ADDENDUM #3

Project	Nelson H.S. Renovations	Project No.	2323
Location	4181 New Street, Burlington, Ontario	Date of Issue	2024 05 31
Owner	The Halton District School Board	File	2323/7.1.3

This Addendum forms part of the Contract Documents and amends the original Drawings and Specifications, dated 2024 05 13, as noted below.

6 ROOF SECTION DETAIL @ PIPE PENETRATION
A502 1:5

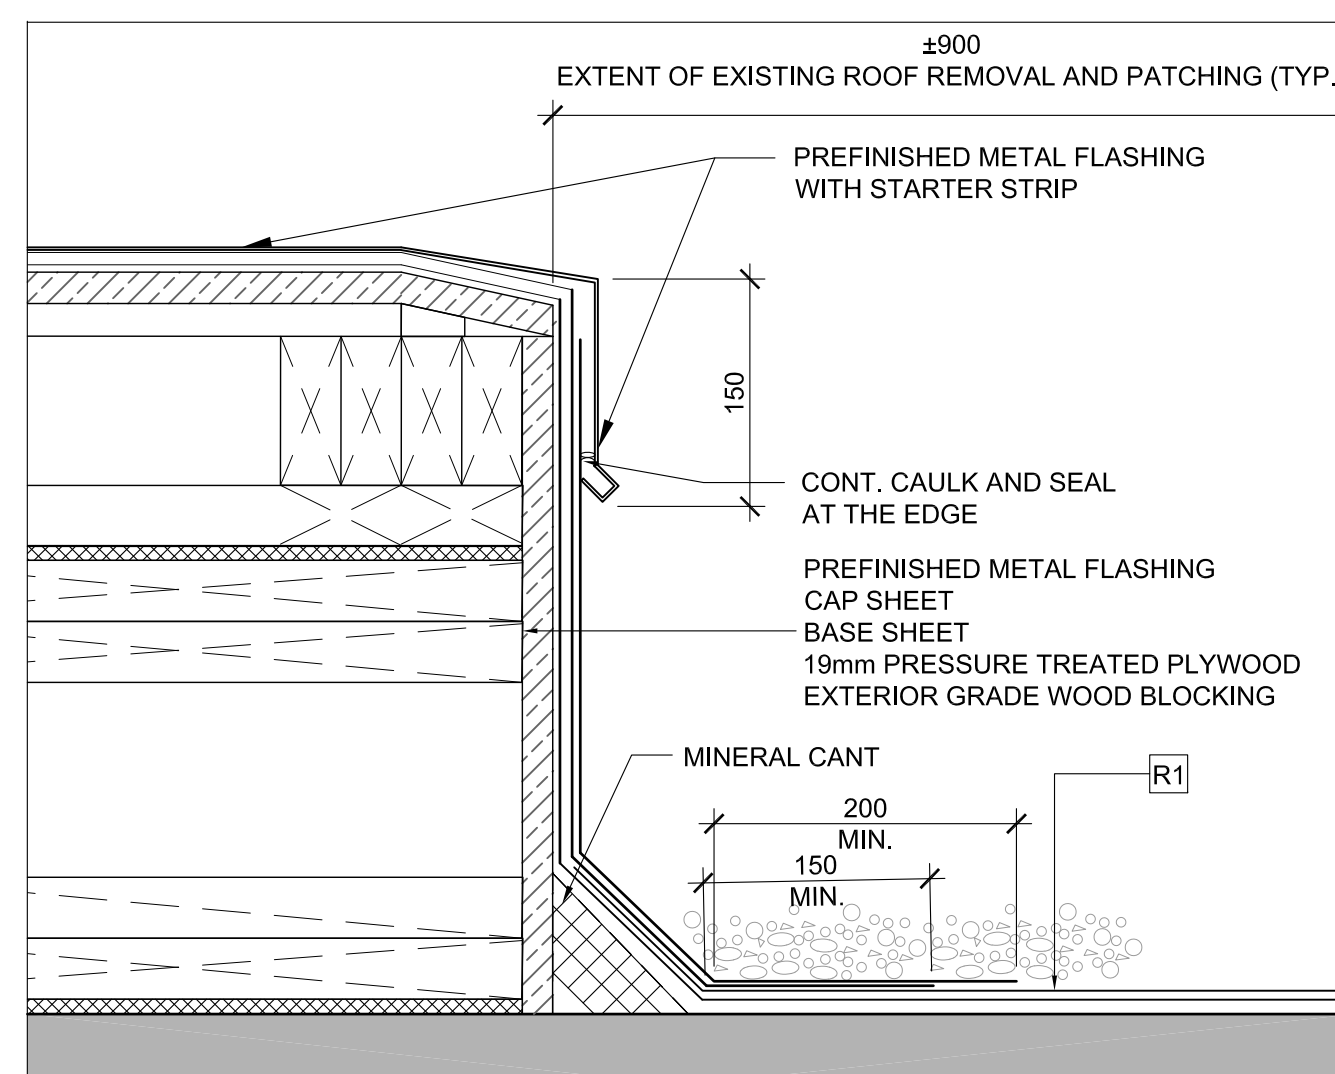
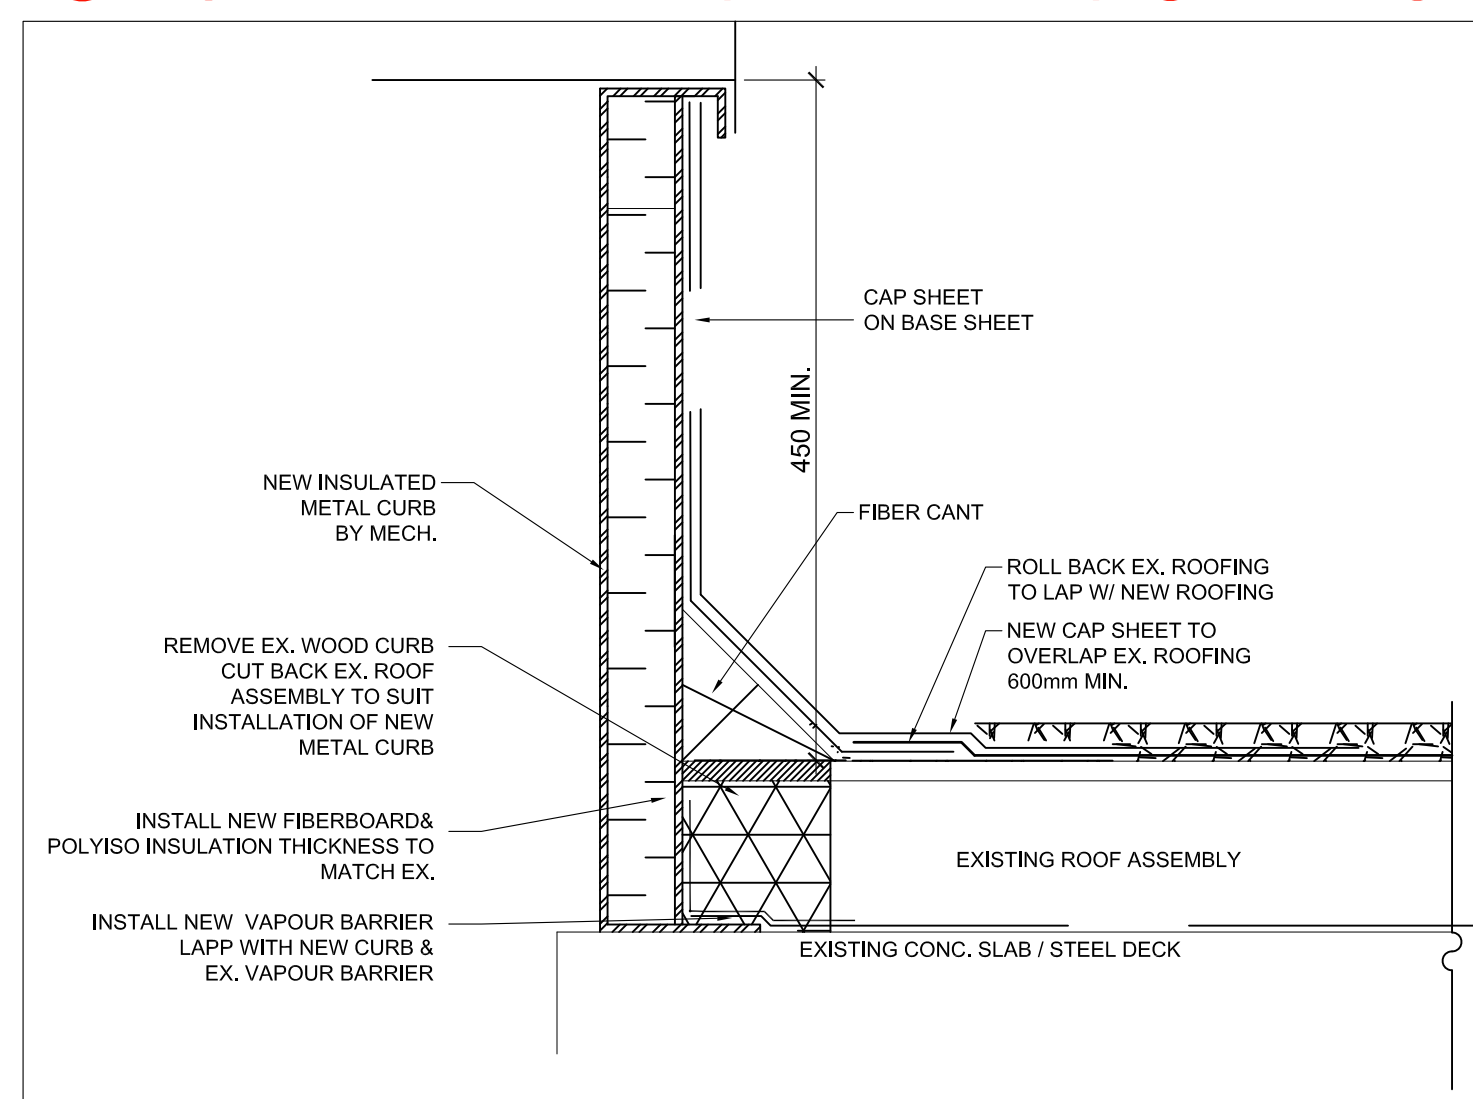
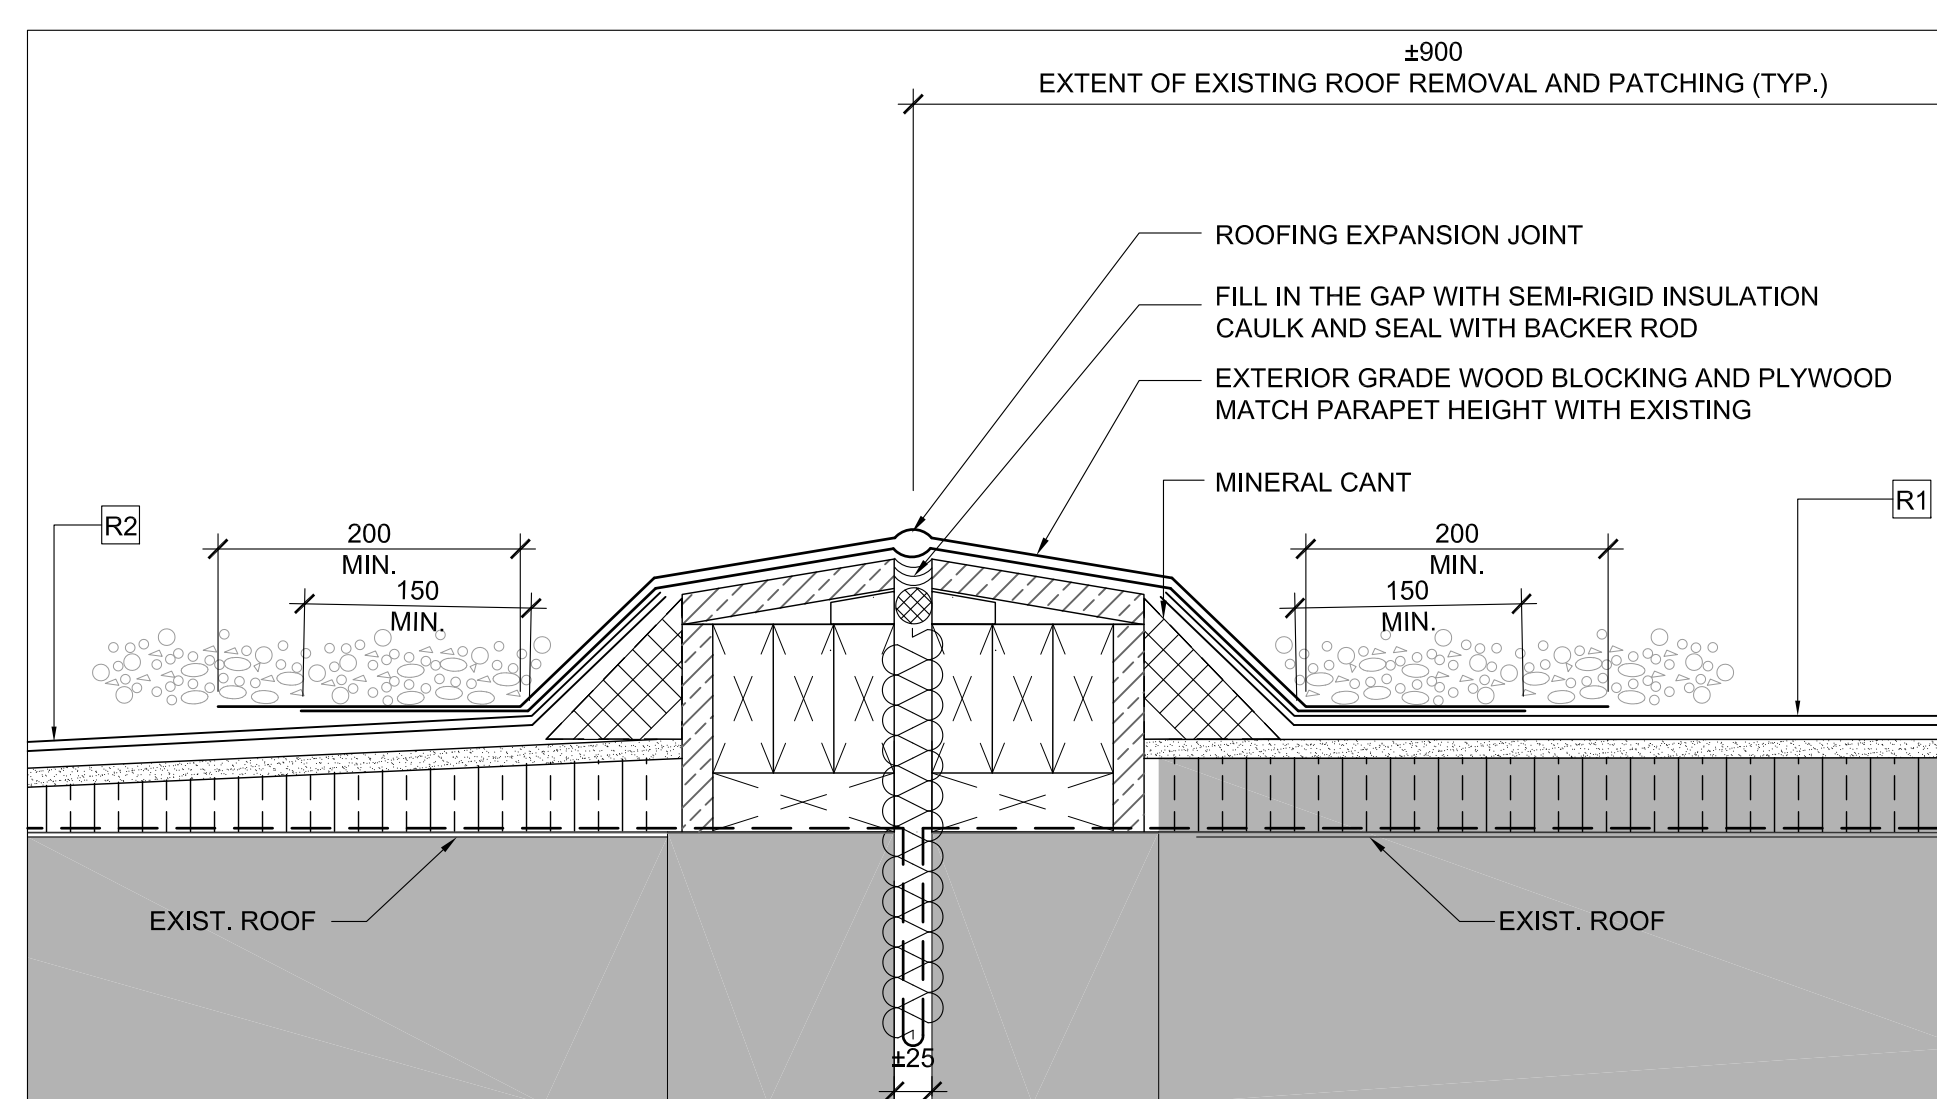
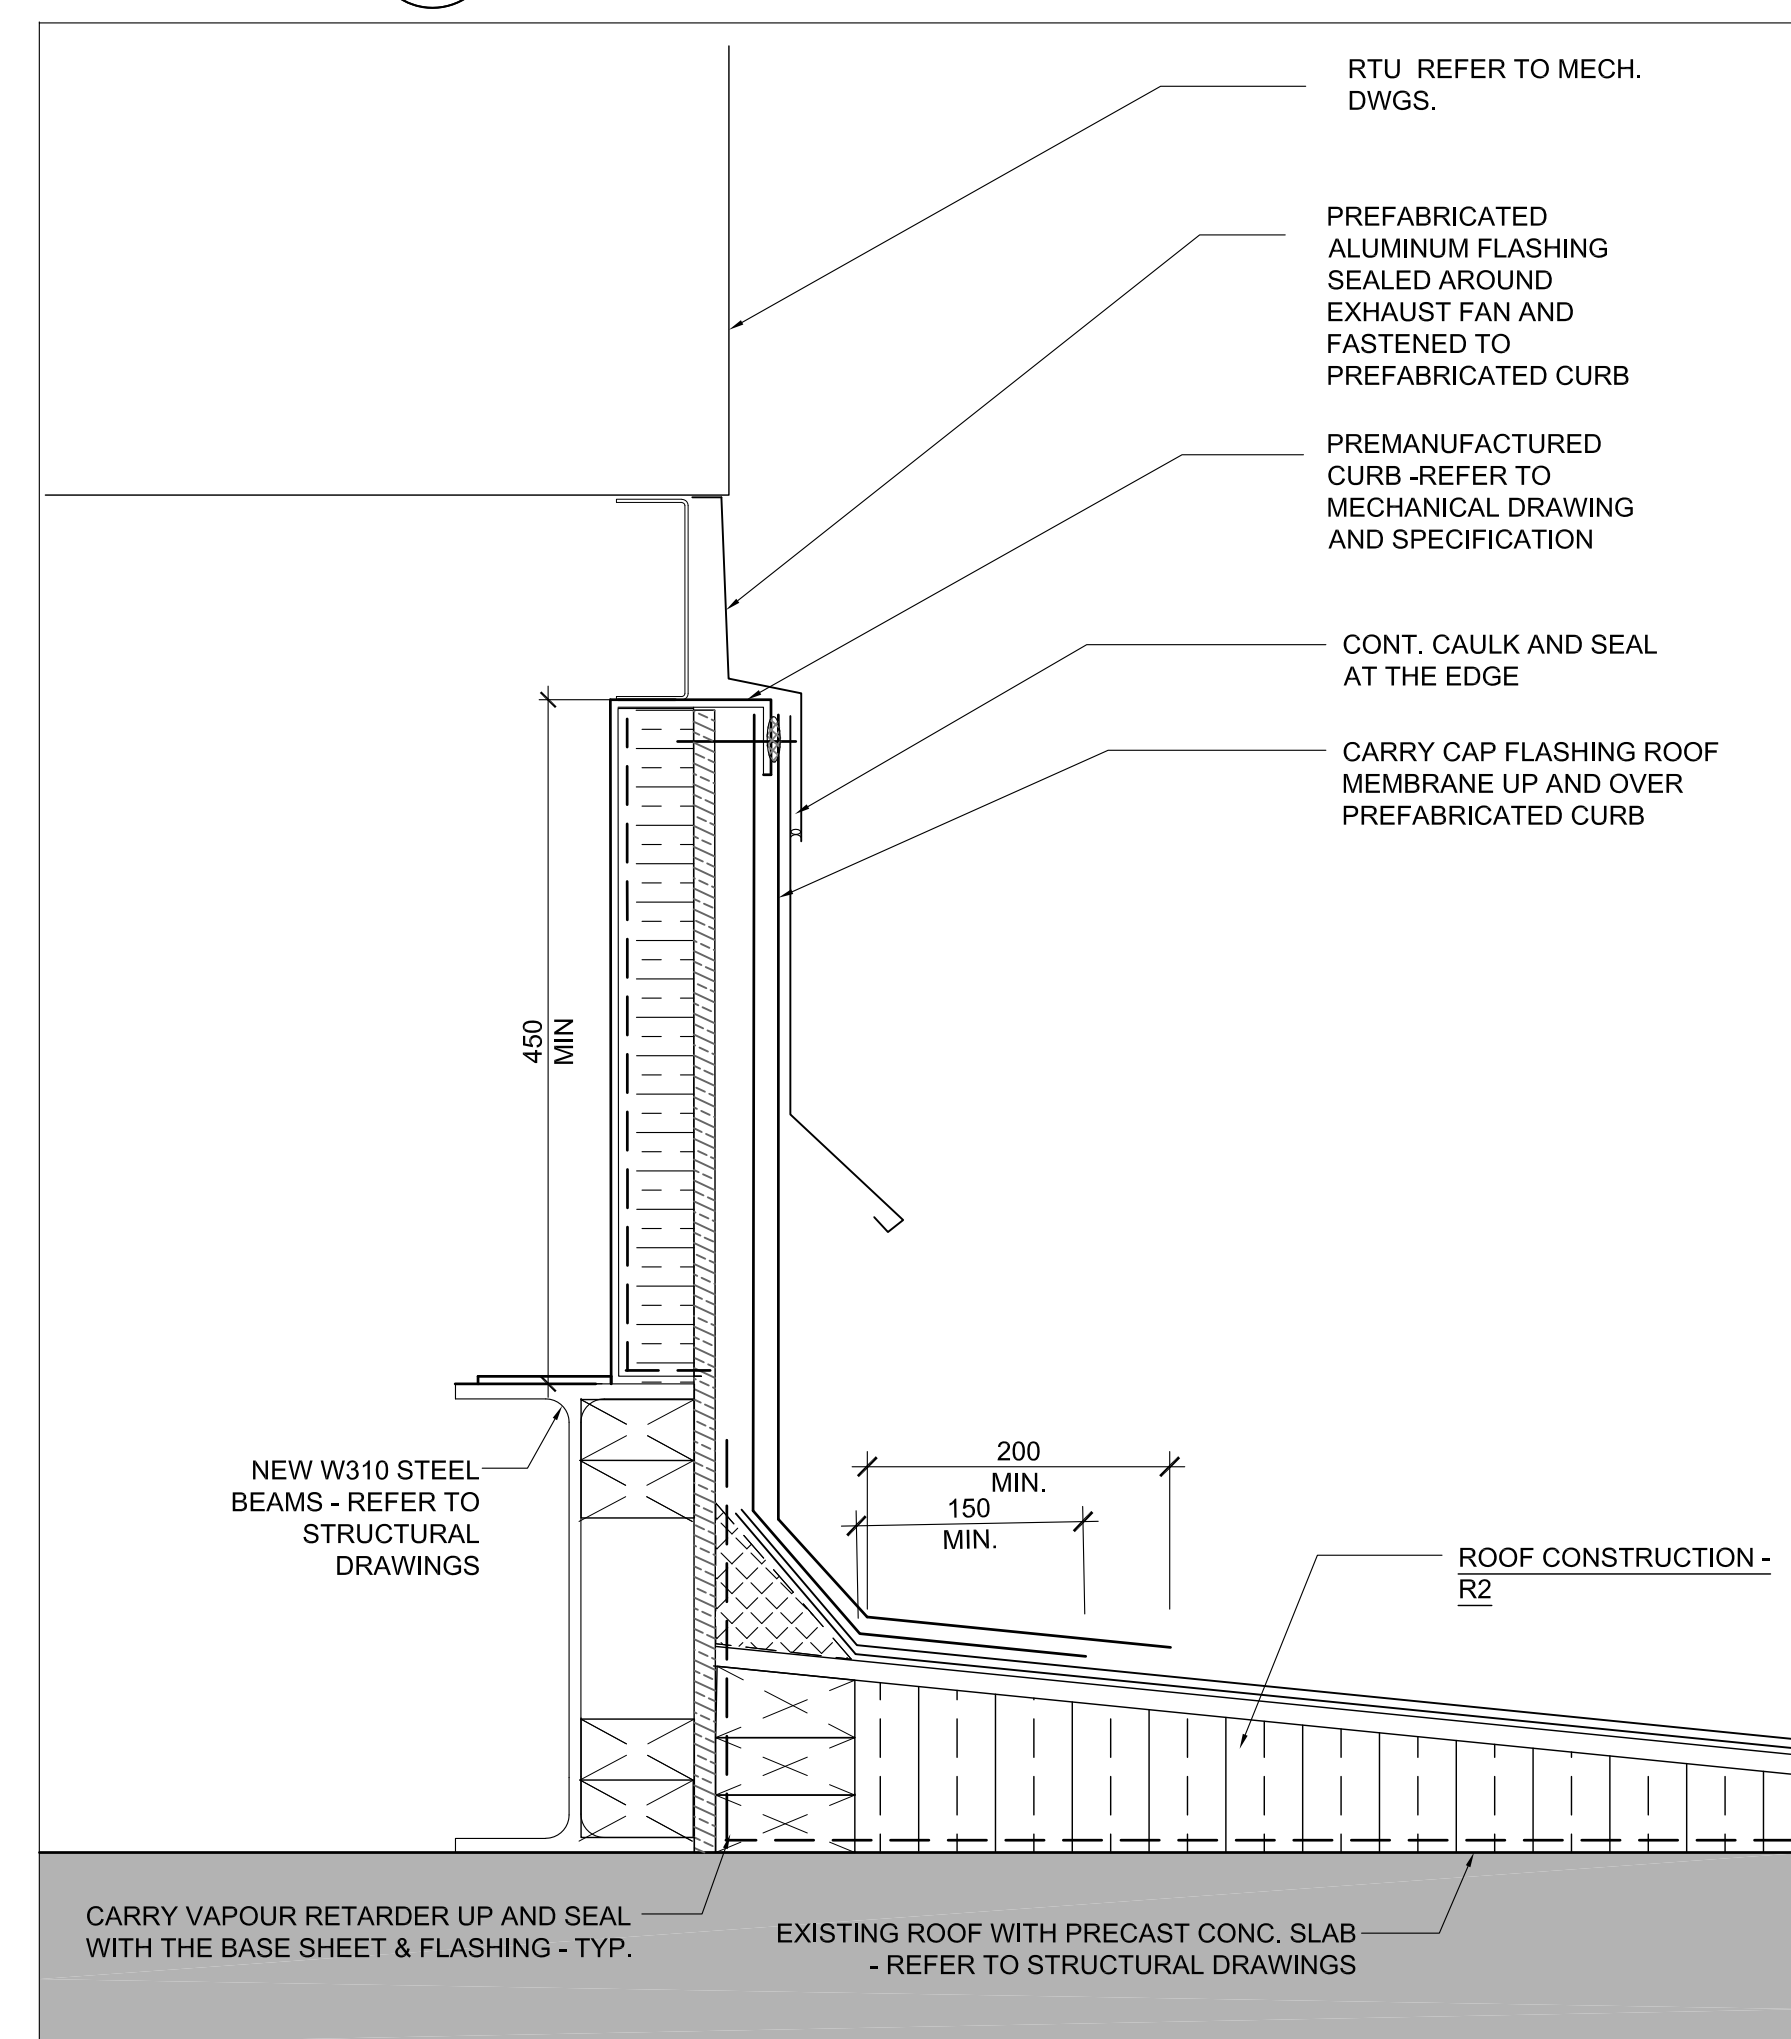
A3-12 DRAWING A502 ROOF SECTION DETAILS (reissued)

- .1 Replace drawing with re-issued drawing
- .2 Replace detail no. 1, 2, 4 and 5
- .3 Add detail no. 3, 6, 7, 8, 9 and 10

Q5 – Who provides the wood blocking required at roof details, parapets, curbs?

A5 – All wood blocking required for roofing as indicated on drawing A502 Roof
Section Details By SC07 ROOFING
